<b>Subject:</b>  TAPPING NOISE COMING FROM FRONT SEAT BACK	<b>Bulletin No:</b> 09-030/12
	<b>Last Issued:</b> 08/02/2012

2013 CX-5 vehicles with VINs lower than JM3KE\*\*\*\*\*116881 (Produced before April 4, 2012)

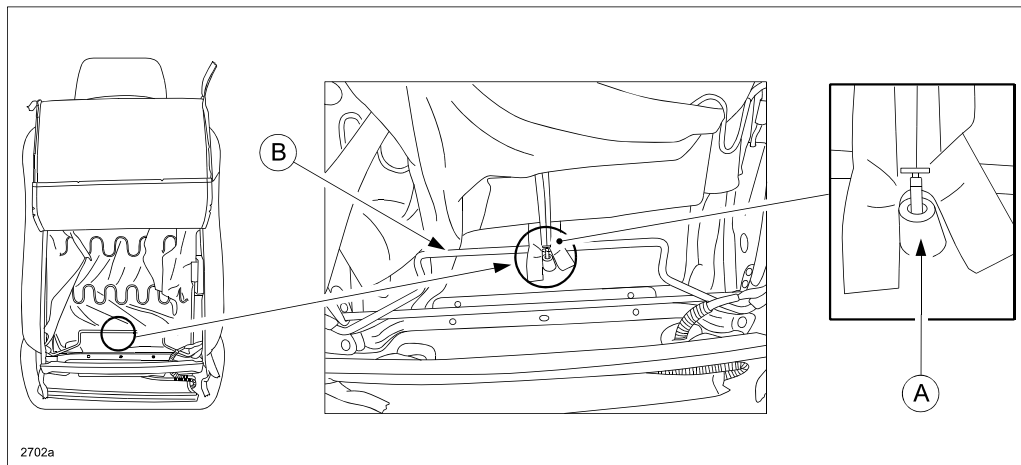
Some vehicles may exhibit a tapping noise from inside the front seat back while driving on rough road surfaces. The seat may also shake during rapid vehicle acceleration or deceleration. This concern may be caused by contact between the plastic slider (A) and seat rod (B).

To eliminate this concern, a piece of urethane has been attached to the center of the seat rod to prevent contact with the slider.

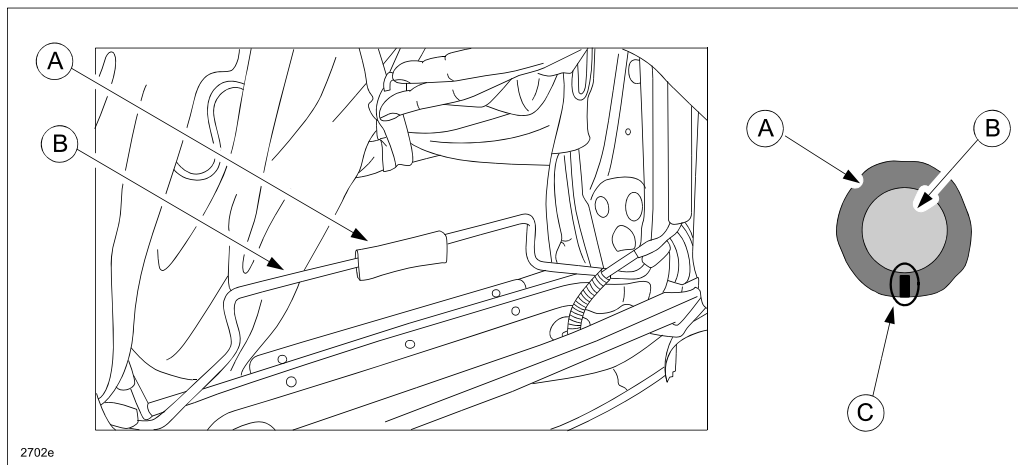
6. Cut one (1) piece of 5 mm thick urethane (from Noise Repair Kit) into a 40 mm x 70 mm piece.
7. Affix the piece of urethane (A) onto the center of the seat rod (B) with the edges of the urethane facing downward (C).
